Validation of VSR Module to Host link

- **Work done for OIF and presented in OIF2013.170.4 to close comment on VSR draft 9.**

Problem Statement Vertical Stressor

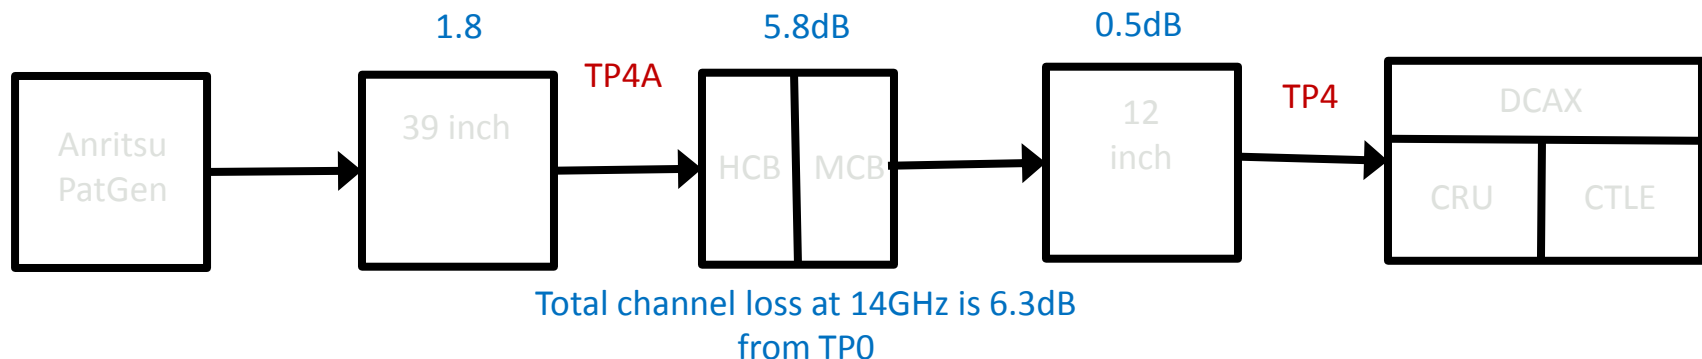
- VEC introduced in [oif2011.418.01.pptx](#)
- Measured with CTLE applied
- From Rev9: “At TP4 passing is defined as a single equalizer setting that meets the EH15, EW15 **and** VEC specifications”
- Comment to Rev8 Added VEC must be met and can be construed that the host test must meet it also.

TP4 with 2dB of CTLE and TP0 stress

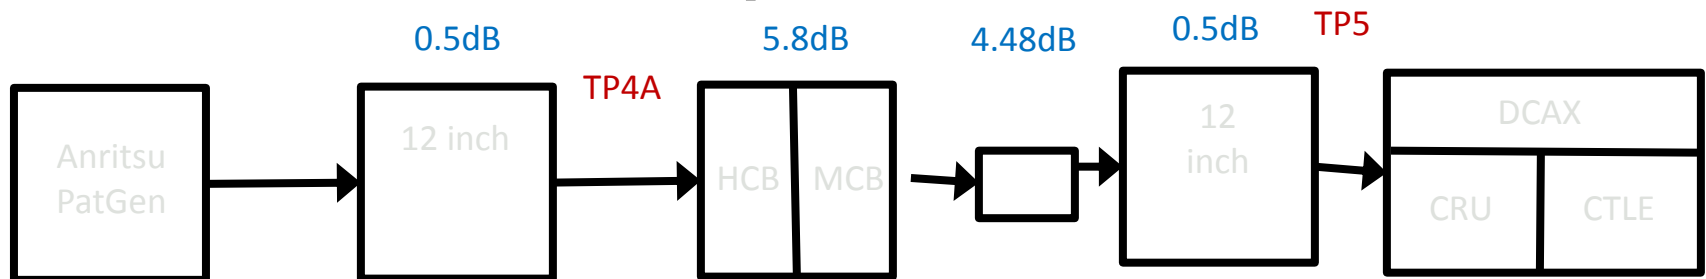
- Channel Loss
- 6.3dB
- Spec 5dB
- EW15=634mUI
- Spec 570mUI
- EH15=180mV
- Spec 228mV
- VEC= 4.9dB
- Spec 6.5dB

TP4-TP5 test channel

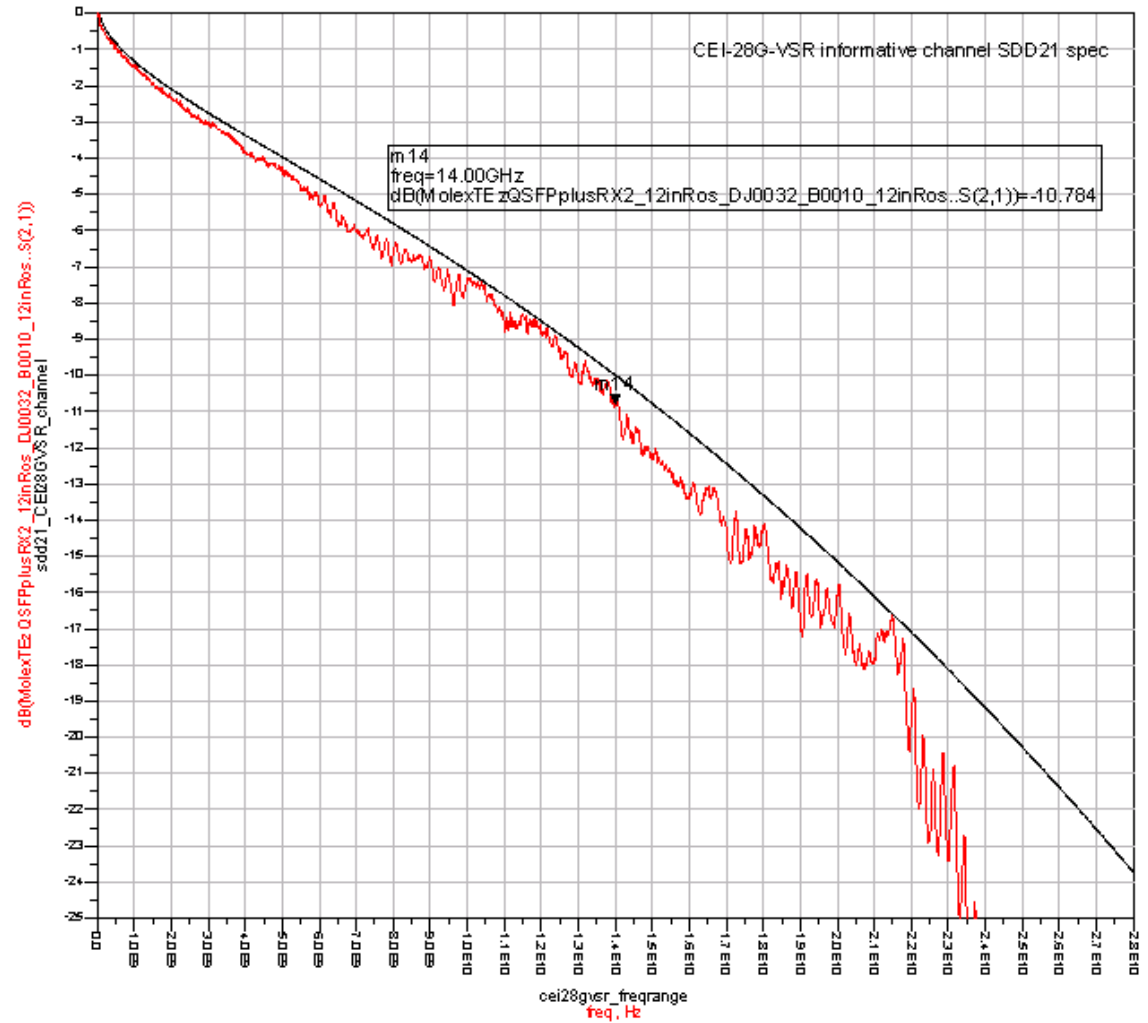
- Channel Loss
- 10.78dB
- Spec 10dB
